Property Inspection Report

OPEN FRAME

Sammy Slumber
4830 Franklin Way Court
Iowa Colony, TX 77583
Meridiana

Plan: Lindsay

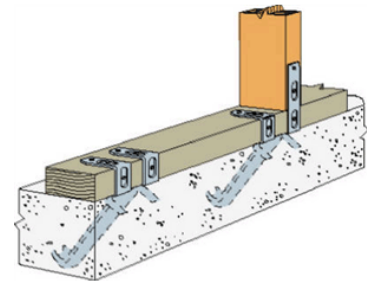
Information: While, there were no anchor bolts installed in the sill plates of the exterior walls, we did observe Simpson Strong-Tie® Mudsill anchors that meet or exceed the anchorage requirements. *Refer to design specifications.*

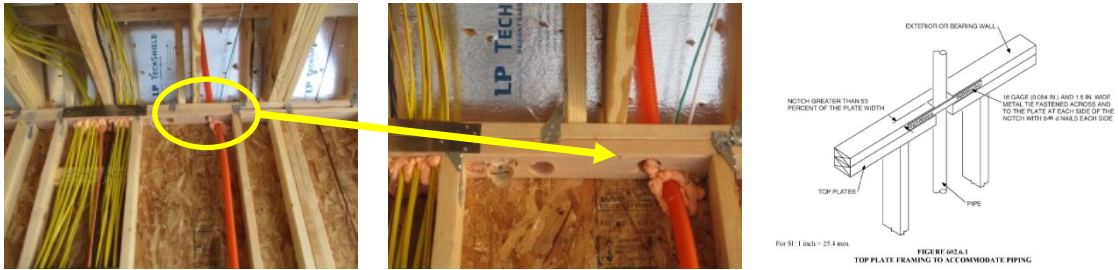
Where drilled anchor bolts were placed, washers were undersized (7 or more locations). In this Inland II area, the washer should be a 2" x 2" plate washer. Recommend correction or a written letter from the design engineer showing acceptance as installed. [Wood Frame Construction Manual](#)

Illustration

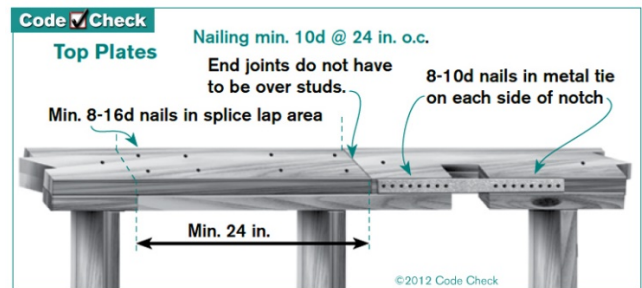
Splices in the upper and lower top plates did not have enough fasteners where sampled. FASTENING SCHEDULE requires eight (8) 16d (3-1/2" x 0.135") nails in lapped area. Since the house has been decked and roofed, these can be driven from below. [2015 IRC Table R602.3\(1\) Default Recommendation](#)

Minimum 8-16d nails in splice lap area (4 each side)
